Proposed Code Modifications

This document created by the Florida Department of Business and Professional Regulation -
850-487-1824

TAC: Fire

Sub Code: Building

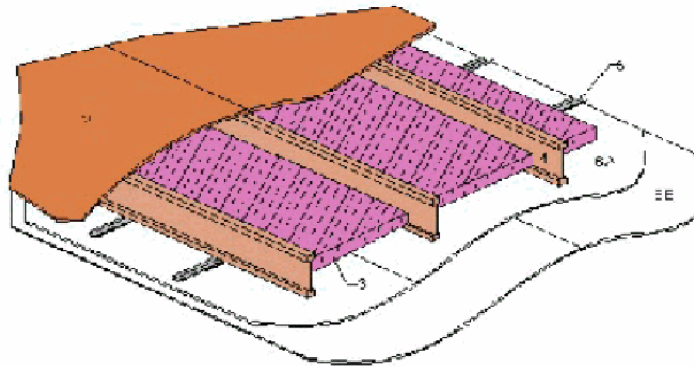
Reason: This proposal, in our opinion, is an editorial change as it simply is provided to correct what is currently specified in the 2015 IBC. The current text entry as published in the 2015 IBC is not correctly shown as the current code does not specify the resilient channel requirement as shown in the following link and the figure shown in the reason. This figure was referenced in the AWC code proposal submitted last code cycle and approved by the membership. (http://www.awc.org/publications/dca/dca3/WJ-1.7.1-joist_2-layers_with_RCs.htm)
 The reason statement for including this proposal previously in the 2015 IBC stated:

Figure 1

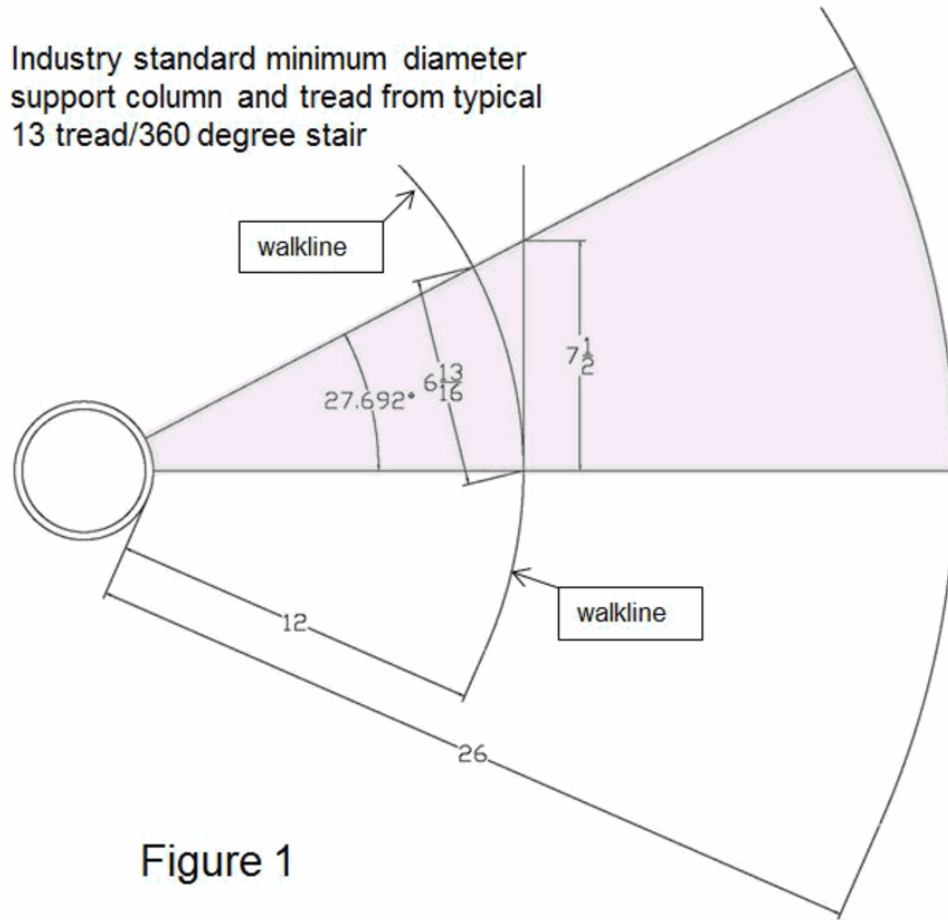
Winder tread depth is measured "between the vertical planes of the foremost projection of adjacent treads at the intersections with the walkline". The change in the method of measurement results in a smaller dimension, for the same tread, that is $\frac{1}{8}$ inch smaller in depth as illustrated in figure 1. The figure also illustrates the elements of spiral stair tread geometry. If the code is not changed, each tread in the typical spiral stairway would need to be increased by $\frac{1}{8}$ inch from the longstanding accepted practice. The proposed dimension change preserves what has been the industry standard for the manufacture of spiral stairways since the legacy codes.

A *spiral stairway* shall have a ~~7-1/2~~ 6-3/4 inch (~~191~~171 mm) minimum clear tread depth at a point 12 inches (305 mm) from the ~~narrow edge~~ walkline. The risers shall be sufficient to provide a headroom of 78 inches (1981 mm) minimum, but riser height shall not be more than 9-1/2 inches (241 mm). The minimum *stairway* clear width at and below the handrail shall be 26 inches (660 mm).

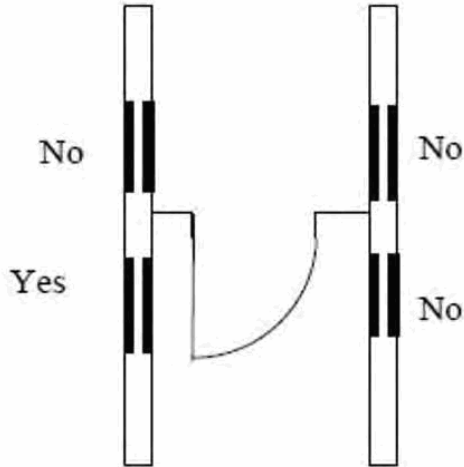
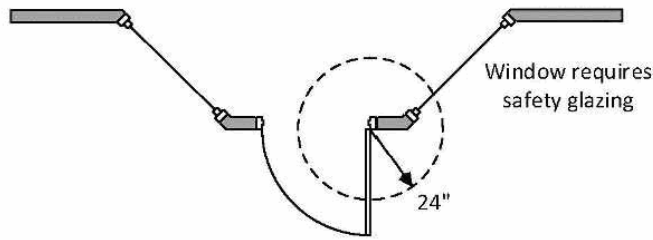
Commenter's Reason: This public comment clarifies when safety glazing is required for an in-swinging door. The original requirement was introduced into the 2015 IRC through code change proposal RB111-13. Based on the figures included in the reason statement (one of which is reproduced below) and the discussions on the proposal, our understanding is the concern being addressed by this provision is that a person can get pinned between the door and the wall, forcing the person against the glazing. The requirement safety glazing in this particular provision is not to address trip/fall/slip hazards, else it wouldn't only be required on the hinge side of the in-swinging door as shown in the figure for RB111-13

However, this proposed change can be interpreted to apply to situations where there is no danger of pinning a person between the door and the window. The figure below illustrates a situation where the wall bends away from the hinge side of the door. In this case, the door swing will be limited by the hinges and the walls, and there is no hazard from the door, but given the text of this proposal only refers to "not in the plane" of the door, safety glazing would be required in the window as shown.

The proposed modification will clarify that only if the window is in a position where a person can get pushed against the window by a door, will safety glazing be required.

R308.4.2 Glazing adjacent to doors. Glazing in an individual fixed or operable panel adjacent to a door shall be considered to be a hazardous location where the bottom exposed edge of the glazing is less than 60 inches (1524 mm) above the floor or walking surface and it meets either of the following conditions:

1. Where the glazing is within 24 inches (610mm) of either side of the door in the plane of the door in a closed position.
2. Where the glazing is on a wall perpendicular to less than 180 degrees from the plane of the door in a closed position and within 24 inches (610 mm) of the hinge side of an in-swinging door.
